CNL responses to federal, provincial and Indigenous information requests (IRs) on the draft revised environmental assessment statement for the proposed WR-1 In Situ Decommissioning Project

April 2023

TABLE 1: CNL Responses to Federal, Provincial and Indigenous information requests on the draft Environmental Impact Statement, December 2022

Figure 6.8.1-5: Manitoba Métis Federation Governance Structure

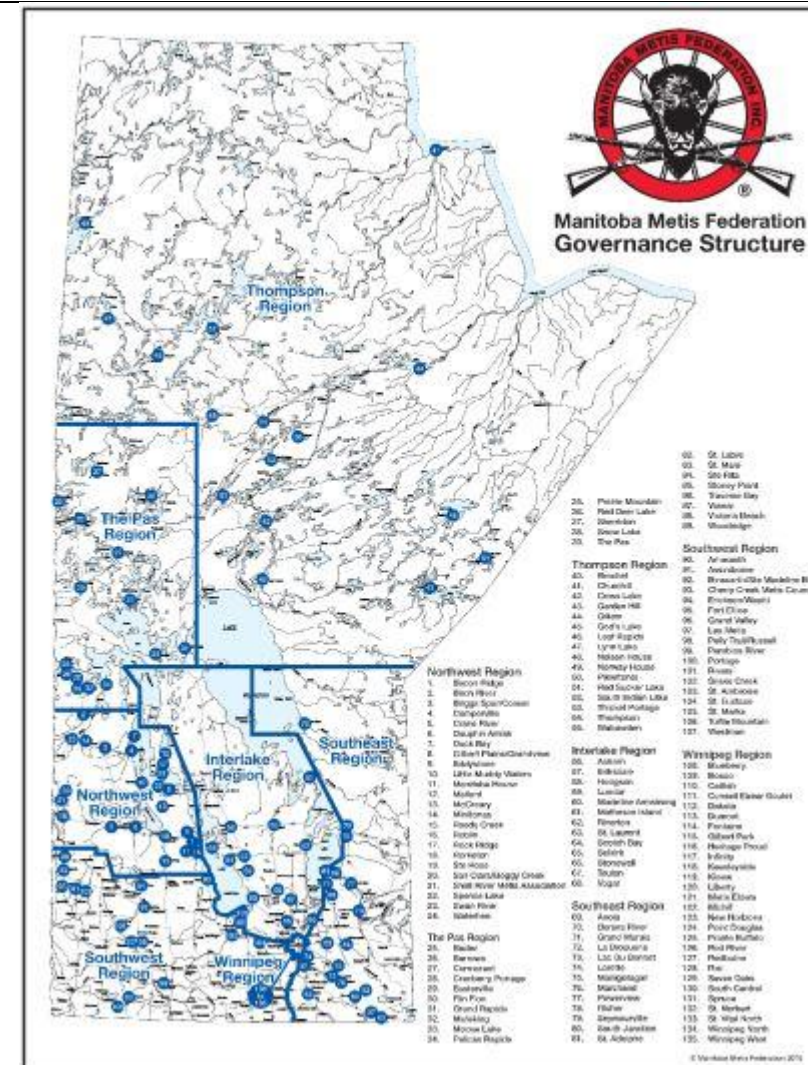
2.	CNSC	EIS - All - General	<p>Comment: References in the EIS to the Métis [note: accent is required on the word ‘Métis’] are often inaccurate and reflect a lack of understanding of the Métis history, the Métis Nation and its citizens. On p.xvii of the Executive Summary, for example, there is an erroneous statement: “The Project is located in the homeland of the Métis Nation, as represented by the Manitoba Métis Federation on Treaty 3 land.” The numbered treaties were negotiated between the Crown and First Nations. Treaty 3 of 1873 was negotiated specifically between the</p>	<p>Incorporated:</p> <p>The Environmental Impact Statement (EIS; Golder 2022a) and EIS Executive Summary (Golder 2022b) were reviewed and revised, as necessary, to include an accent on the word ‘Métis’. The EIS Executive Summary (Golder 2022b) was revised to correct the quoted erroneous statement. Section 6.8.1.5.2.2.1 of the EIS (Golder 2022a) was revised to include more detail on the Métis people and their history. Section 4.2.2 of the EIS (Golder 2022a) was added to provide an overview of which First Nations are signatories on which treaties; Appendix C of the Indigenous Engagement Report (IER; CNL 2022) provides more detail on the pertinent treaties.</p> <p>Change to EIS:</p> <p>Section 6.8.1.5.2.2.1 of the EIS (Golder 2022a) has been revised as follows to include more detail on the Métis people and their history:</p>	On hold for Sagkeegn First Nation (SAFN)

IR No.	Department/ Agency	Section Table or Figure	Information Request or Summary of Comment	Response by CNL	Accepted/ Request for follow-up information
			<p>Dominion of Canada and the Saulteaux Tribe of Ojibway Indians.</p> <p>Expectation to Address Comment: The EIS should clearly describe who the Métis people are, as a distinct peoples, and their history (i.e., in terms of not having a land base with the exception of northern Alberta). It may also be useful to provide some more detail and clarity regarding each pertinent treaty (i.e., Treaties 1, 3 and 5) and which First Nations are signatories to those treaties.</p>	<p><i>“Manitoba Métis Federation</i></p> <p><i>Three Indigenous peoples are constitutionally recognized by the government in Canada, as per s.35 (2) of the Constitution Act, 1982. First Nations, Inuit and Métis. The term “Métis” is defined by the Métis National Council (MNC) as: “a person who self-identifies as Métis, is distinct from other Aboriginal peoples, is of historic Métis Nation Ancestry and who is accepted by the Métis Nation.” (MNC 2022). The MNC is a federally recognized national administrative and representative body for the Métis Nation both nationally and internationally since 1983. Five democratically elected provincial organizations exist within Canada and are comprised of regional councils, community councils and Métis locals. The Manitoba Métis Federation is one of these provincial organizations, alongside the Métis Nation of Ontario, Métis Nation Saskatchewan, Métis Nation of Alberta and Métis Nation of British Columbia. The Manitoba Métis Federation is the democratically elected self-government representative of the Manitoba Métis also known as the Red River Métis, an “Aboriginal peoples’ under Section 35 of the Constitution Act, 1982 and currently includes the Manitoba Métis Federation Inc., a non-share corporation incorporated pursuant to the laws of Manitoba. Founded in 1967, the Federation has over 650 staff across the province (MMF 2018a).</i></p> <p><i>The Manitoba Métis Federation represents and advance the interests of the Métis people of Manitoba and uses an electoral process where all formal positions are elected by Federation members in each designated Region or Local. Governance includes: a President, Board of Directors, regional associations or “Regions” and community-level “Locals”. The President functions as the Federation leader and spokesperson and Chief Executive Officer. This position oversees day-to-day Federation operations and is elected through a province-wide election every four years. A Board of Directors, comprised of 23 democratically elected members, provides guidance, leadership and management toward Federation (and its subsidiaries) policies, objectives and strategic direction. Seven Regions across Manitoba are administered by a vice-president and two executive officers, who are also of the Federation’s Board of Directors, and who administer programs and services independently to their specific geographic area. Each Region comprises various Locals. These are administered by a chairperson, a vice-chairperson and a secretary-treasurer, and have a minimum of nine members which meet at least four times a year. Each Federation member belongs to a Local. Specific Locals determine the timing of election of their respective Local representatives, while regional officers are elected every four years (MMF 2018a).</i></p> <p><i>The governance structure of the Manitoba Métis Federation is provided on Figure 6.8.1-5.</i></p>

TITLE
ISOPACH MAP - BASAL SAND

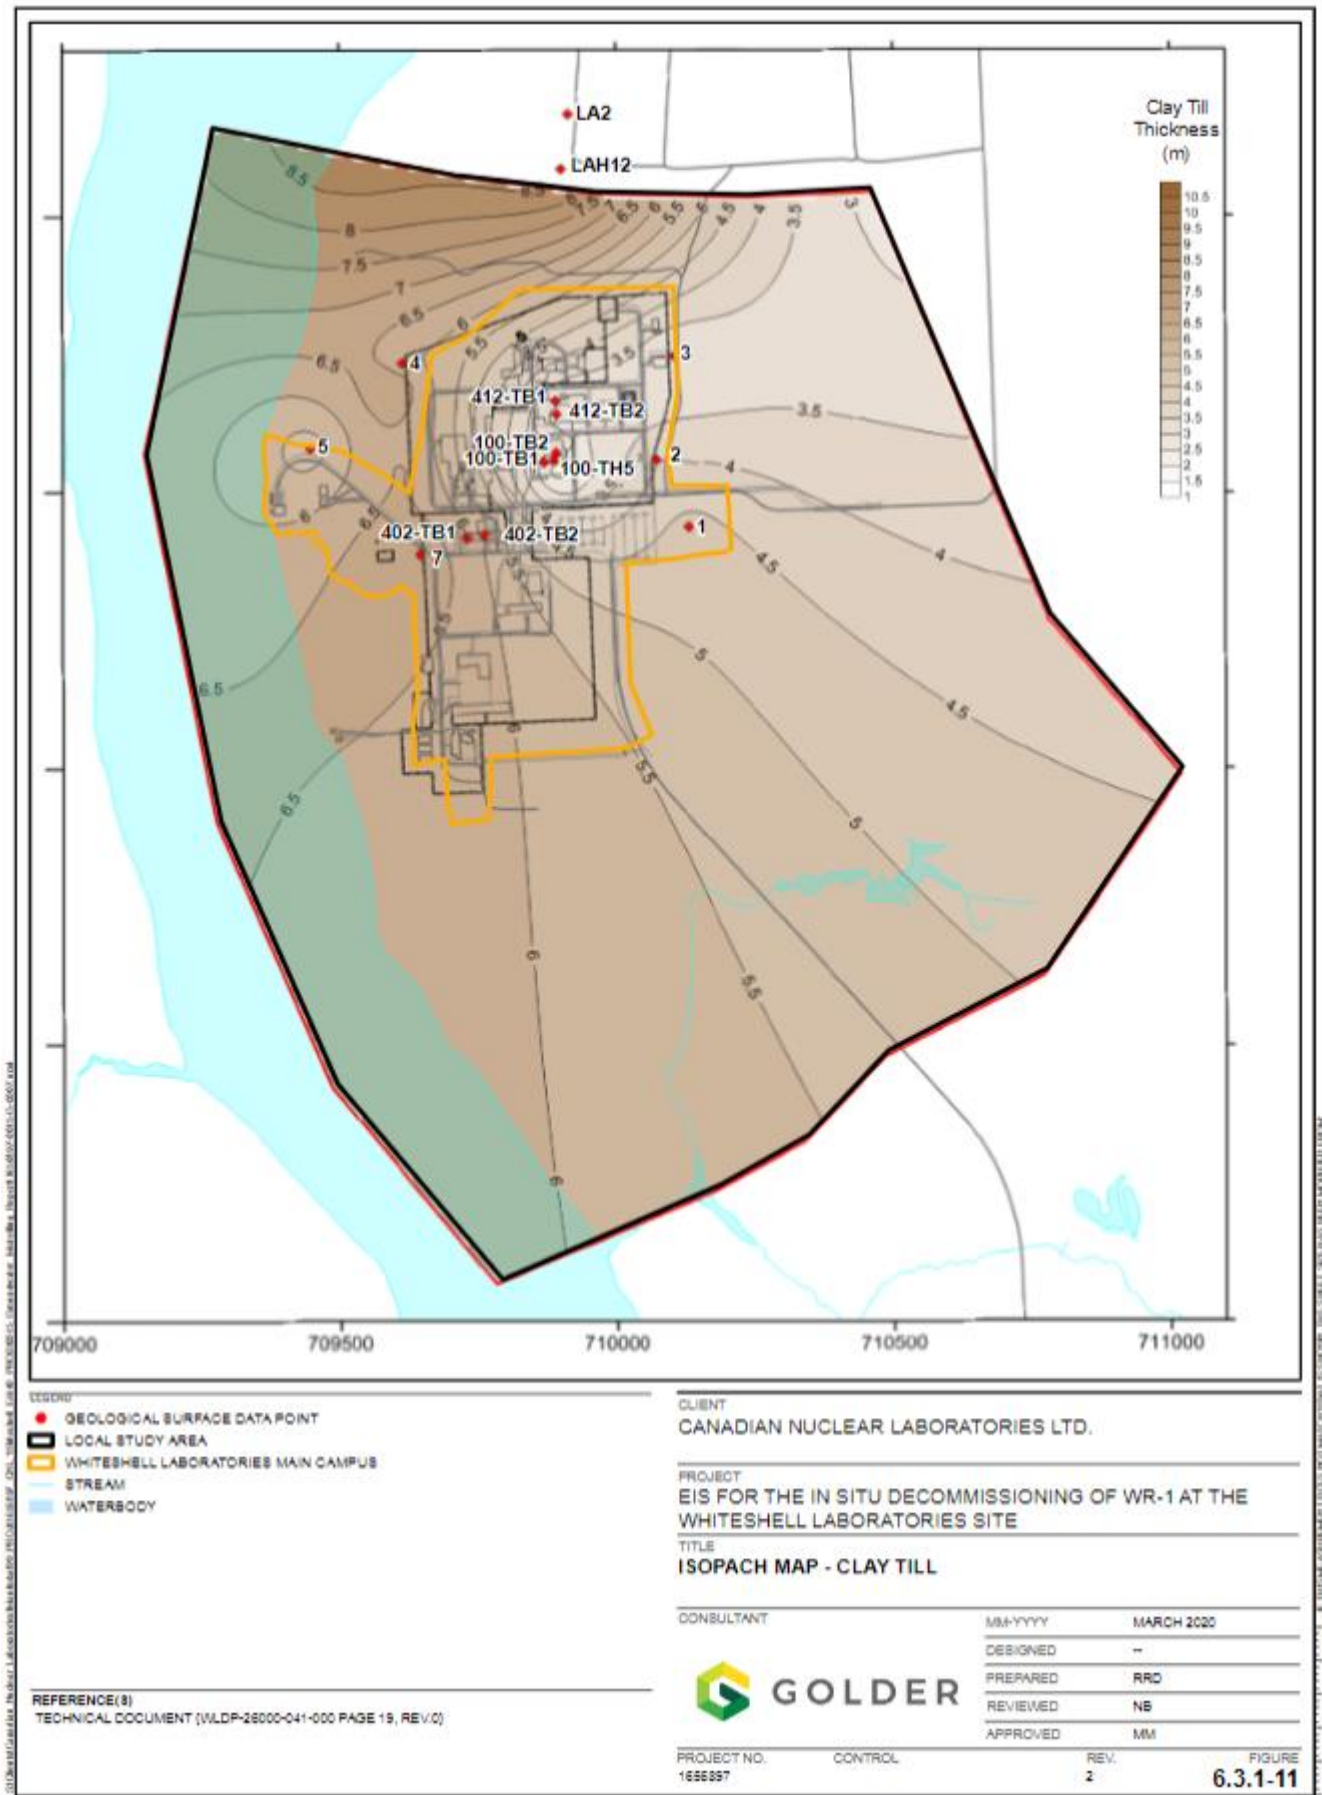
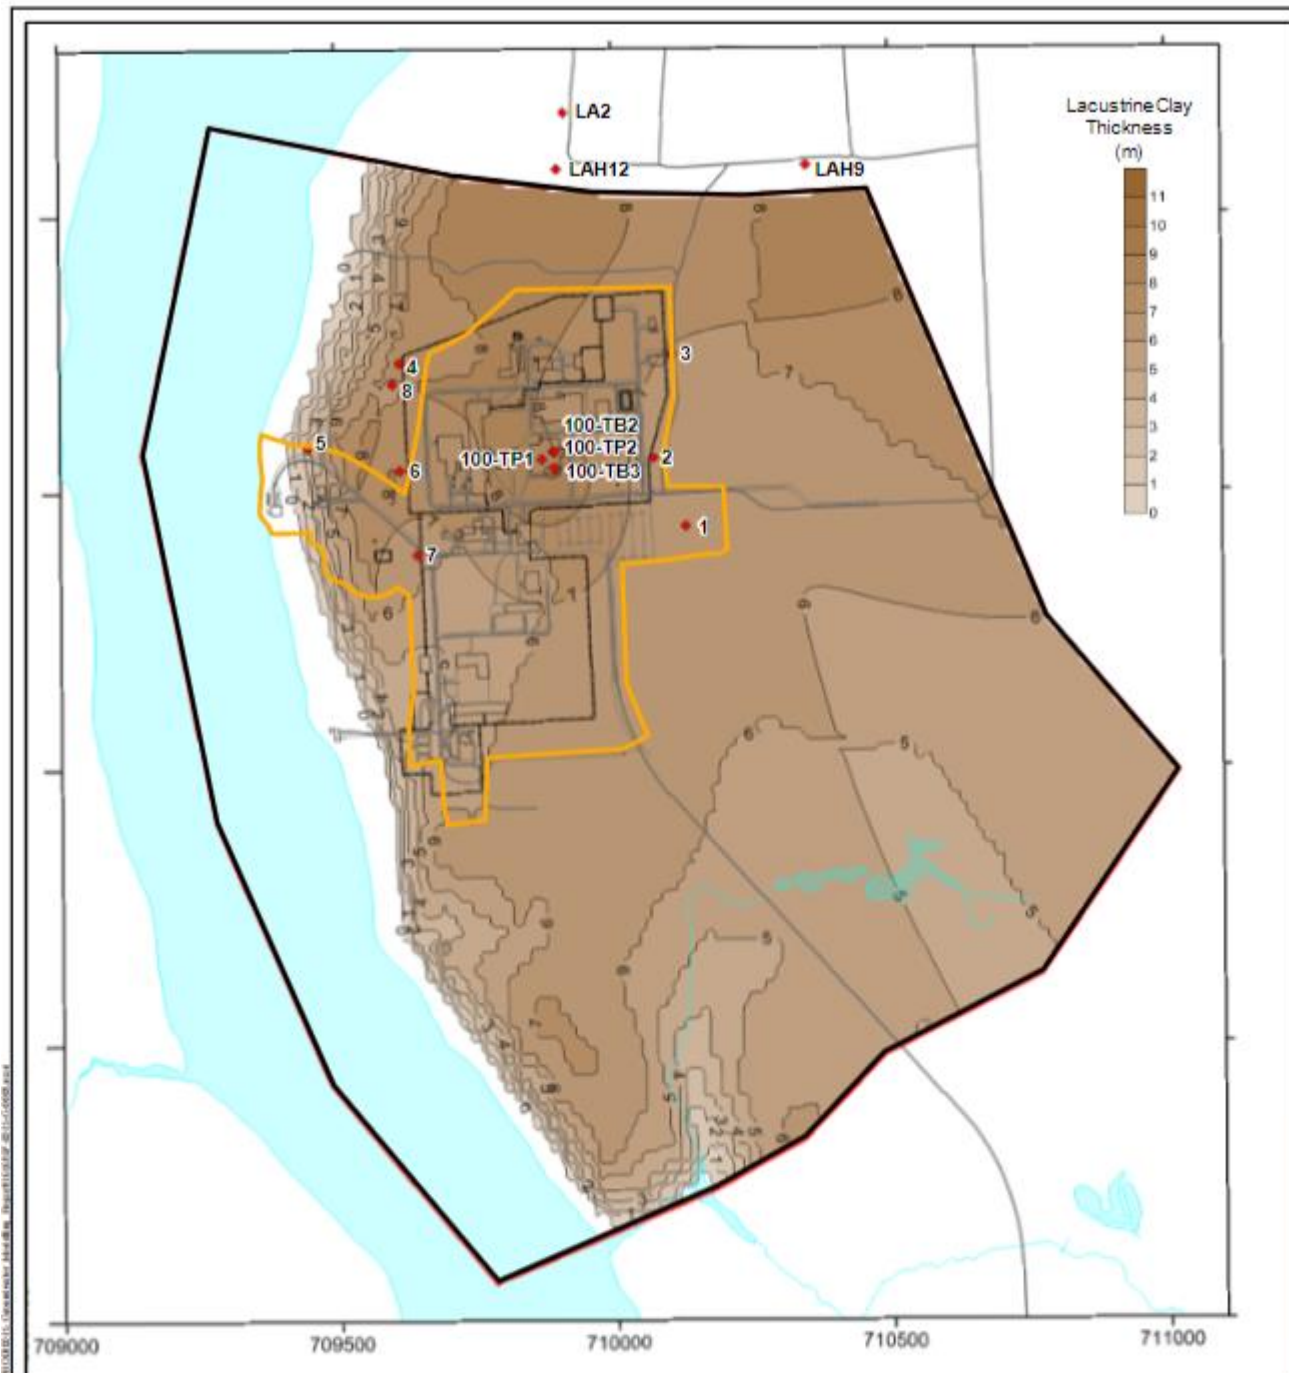
84.	CNSC	EIS - 6.3.1 Geology	<p>Comment: Geological data is missing or too descriptive, without evidence/observations to support statements made in the text, which are at times confusing or contradictory. For example: WN-series boreholes: P.6-77: baseline geological data were “collected from the results of recent drilling” described in Dillon 2017. The locations of the boreholes (names WN-1 and WN-2) are provided on Figure 6.3.1-3 (the scale is such that they are located in the same place) and the results very generally summarized on page 6-85. Where is the data for the WN series bedrock boreholes? It is not located in either the EIS or in the <i>Hydrogeological Study Report</i>. P.18 of the <i>Hydrogeological Study Report</i> describes two depth related zones in the bedrock, with “increased open-fractures in the upper 100m of bedrock”, and goes on to describe an overlying (upper?) 10m competent zone of less fractured rock overlying a zone with “increased fracture frequency approximately 30m into bedrock”. Then refers to the WN-series deep bedrock boreholes stating that the upper bedrock was</p>	<p>Resolved As:</p> <p>CNL has prepared a Geosynthesis Report (CNL 2022) that includes the requested information on the bedrock geology and fracture information.</p> <p>This report provides information to support the Whiteshell Reactor 1 (WR-1) Environmental Impact Statement (EIS; Golder 2022) in three areas:</p> <ol style="list-style-type: none"> 1. A Geosynthesis of the information used to support the EIS and licence amendment application for decommissioning of WR-1; 2. Ensuring that CNSC EIS regulatory baseline geological and hydrogeological requirements of Appendix B.4 of Regulatory Document 2.9.1 (CNSC 2020) and Section 7.3.1 of Regulatory Document 2.11.1 Volume III (CNSC 2018) are met; and 3. Identification of geoscientific data uncertainties and an assessment of their relevance/significance to the decommissioning project. <p>This Geosynthesis (CNL 2022) focuses on summarizing the available geological, hydrogeological and geomechanical information including published scientific literature, WL site characterization reports, information on the regional and local geology developed during the Canadian Nuclear Fuel Waste Management Program, government documentation of area soil and available mapping data from the Manitoba Geological Survey and Earthquakes Canada. Specifically, the summarized data provided in the Geosynthesis draws from and cites numerous reports related to the Underground Research Laboratory geological program. Hydrogeological information is contained in the WR-1 Hydrogeological Study Report (Dillon 2018) but is briefly summarized in Section 3.2 of the Geosynthesis (CNL 2022).</p> <p>The requested data for the WN boreholes indicated in Figure 6.3.1-3 of the EIS is summarized in Section 2.5 of the Geosynthesis (CNL 2022) and provided in the EIS (Golder 2022) in Figure 6.3.1-5. The original source data compiled in the Geosynthesis, including estimates of fracture frequencies, is gathered from reports prepared on the WN boreholes by Lau et al. (1980a, b, c, d, 1982 and 1985a, b.)</p> <p>The bedrock geology information, including the fracture frequencies, composition of the Lac du Bonnet batholith, its phases, regional setting and contacts with adjacent formations, has been synthesized and discussed in Section 2.5 of the Geosynthesis (CNL 2022). Specific to fracture zone locations and frequencies, Figure 6.3.1-5 in the EIS (Golder 2022) provides an overview of the fracture pattern from borehole WN-1, deemed to be</p>	Accepted

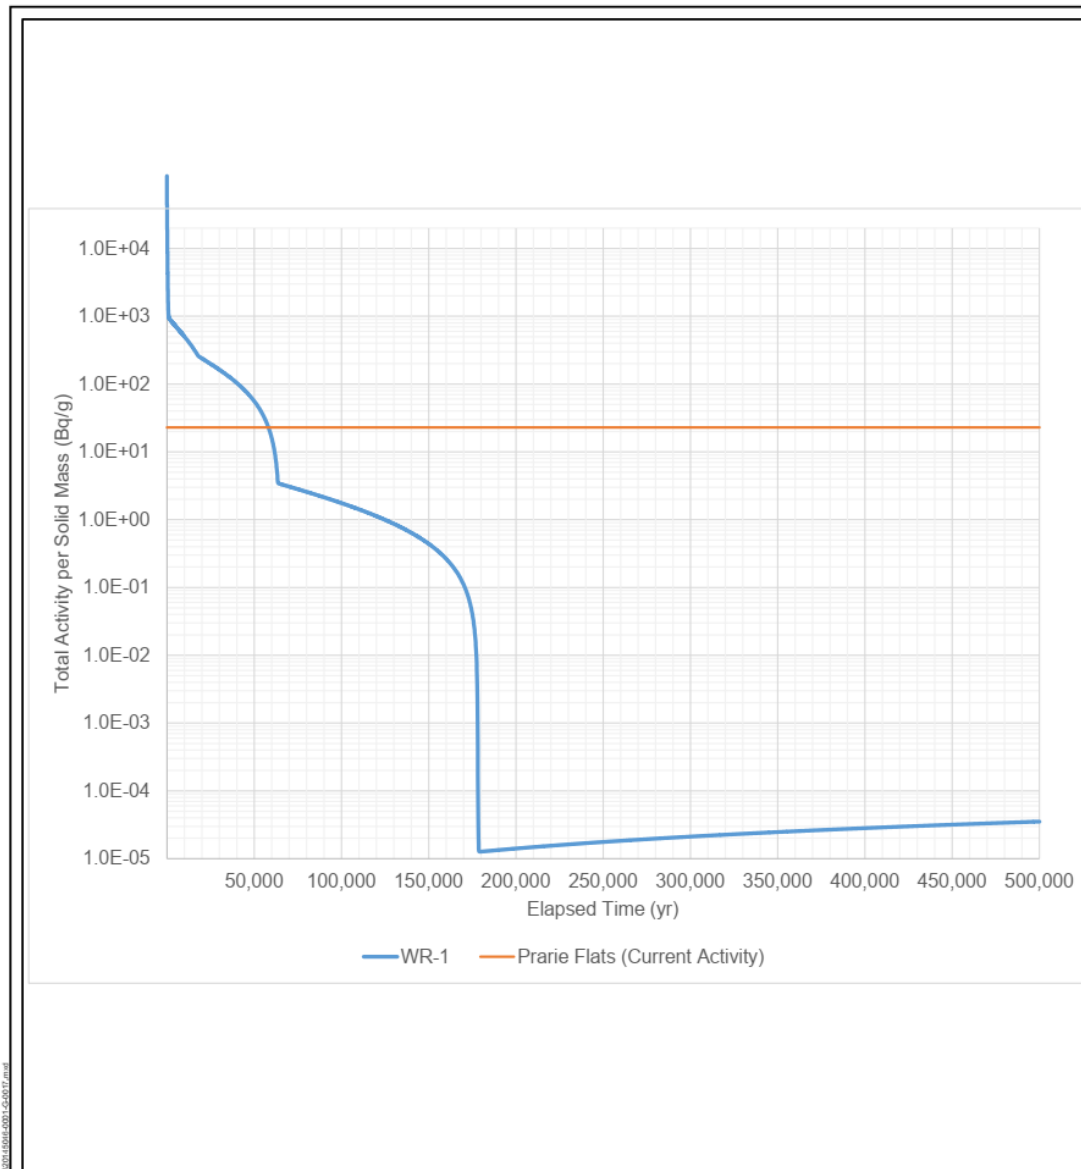
189.	CNSC	DSAR - Section 2.4.3, Figure 2.4.3-1 Time frame	<p>Comment: Selection of a time frame should be supported using a multiple lines of evidence approach, which must encompass the time frame when the maximum impact is predicted to occur, as per P-290. When assessing multiple lines of evidence to support the time frame, consideration should be given to the source-term and the longevity of the source-term, the use of natural analogues, and the period with maximum exposure to critical receptors as per an acceptable Normal Evolution Scenario. It is not clear within Section 2.4.3 of the DSAR how</p>	<p>Incorporated:</p> <p>CNL has significantly revised Section 5.3 of the Decommissioning Safety Assessment Report (DSAR; Golder 2021) to provide evidence to support CNL's rationale for the timeframe selection and explain CNL's estimated decay of the radionuclide inventory and how this estimate was used to support the proposed assessment timeframe.</p> <p>Change to DSAR:</p> <p>Section 5.3 of the DSAR has been revised to include the following text:</p> <p><i>"The assessment timeframe is 10,000 years. The timeframe is established in compliance with the CNSC's REGDOC-2.11.1, Volume III (CNSC 2018a), which requires that, "the assessment of future impacts of radioactive waste on the health and safety of persons and the environment encompass the period of time when the maximum impact is predicted to occur." Per Section 7.4 of CNSC's REGDOC-2.11.1, Volume III (CNSC 2018a) there is no</i></p>	Follow-up IR from the CNSC
